SUPPLEMENTAL BID BULLETIN NO. 1

**SUPPLY, DELIVERY AND TESTING OF FLOAT ASSISTED WALKING-TYPE AGRICULTURAL TRACTORS  
 (PHilMech-RCEF-23-09-24)**

This **Supplemental/Bid Bulletin No. 1** is being issued to clarify, amend and supplement provisions in the Bidding Documents.

### FLOATING TILLER-TURTLE TYPE

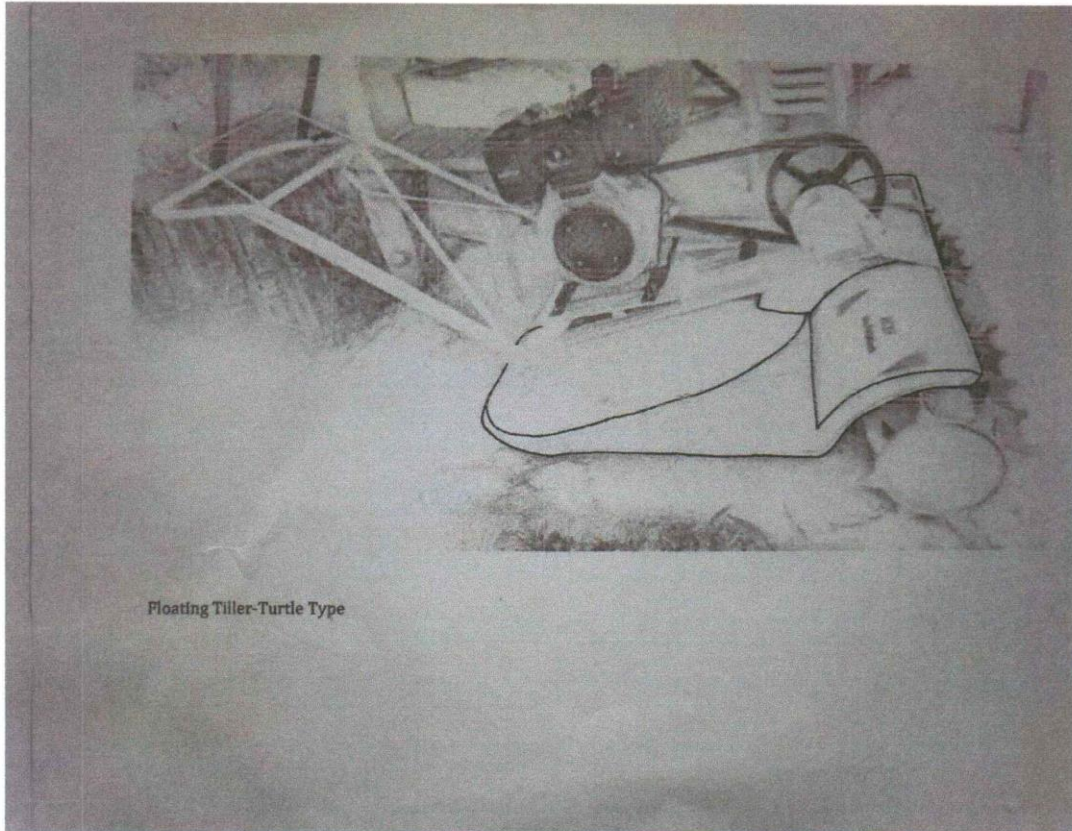
13. <i>Issue / Proposal: - Request for the design of a turtle-type floating tiller.</i>
Action Taken/Reply: <b>Please refer to Annex A.</b>
